Service Bulletin Mazda North American Operations

SEAT SHAKES BACK AND FORTH / MAKES NOISE WHEN BRAKING

Bulletin No: 09-061/09

RX-8, Mazda5 & Mazda6 [with pantograph type seat lifter (A)]:

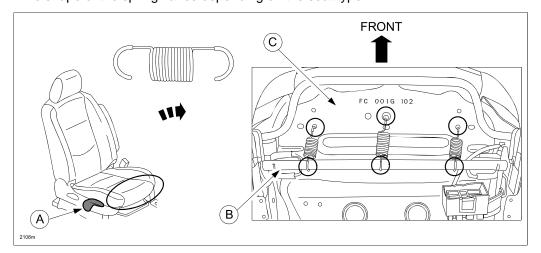
- 1. Verify customer complaint.
- 2. Install three (3) springs to the back of the seat cushion seat pan (C) and pipe frame (B).

NOTE: The shape of the spring varies depending on the seat type.

CX-7, CX-9 & Mazda3:

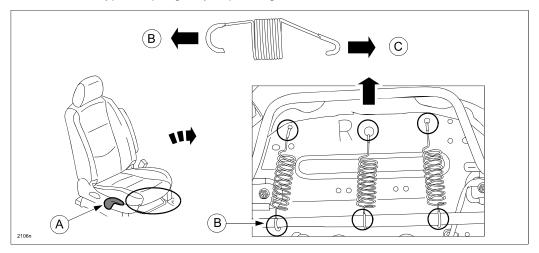
NOTE: The hooks of this type of spring vary depending on which side the hooks fit to.
